DEVELOPMENT APPLICATION ASSESSMENT REPORT

DA2021/2589

Application Hambon	B7 12-02-17-2-000		
Responsible Officer:	Miller French-Lightfoot		
Land to be developed (Address):	Lot 1 DP 6098, 128 Wyadra Avenue NORTH MANLY NSW 2100		
Proposed Development:	Alterations and additions to a dwelling house		
Zoning:	Warringah LEP2011 - Land zoned R2 Low Density Residential		
Development Permissible:	Yes		
Existing Use Rights:	No		
Consent Authority:	Northern Beaches Council		
Land and Environment Court Action:	No		
Owner:	Tracy Leigh Harvey		
Applicant:	Serenescapes Landscape Designs Pty Ltd		
Application Lodged:	12/01/2022

Description of non-compliance

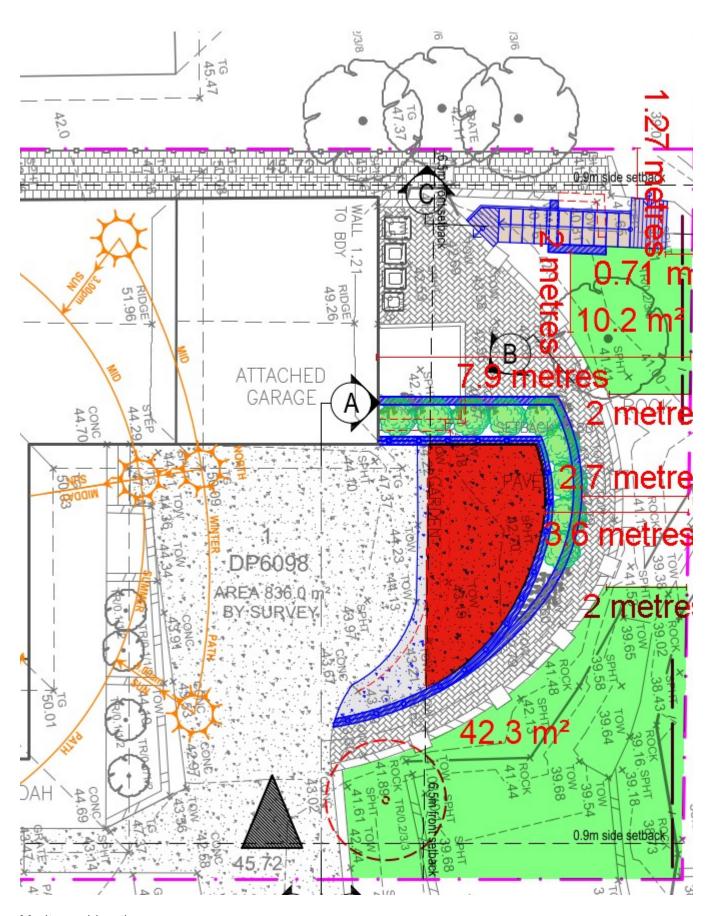
Clause B7 Front Boundary Setbacks prescribes a front setback of 6.5m.

The development proposes a varying front setback. The existing 7.9m front setback of the dwelling remains unchanged, however, the extension of the driveway, sited 3.6m from the front boundary, reveals a non-compliance resulting in a variation of 45% (2.9m).

It is noted that the retaining wall associated with the extended driveway and the stair case sited in the north-west of the site both encroach into the front setback also.
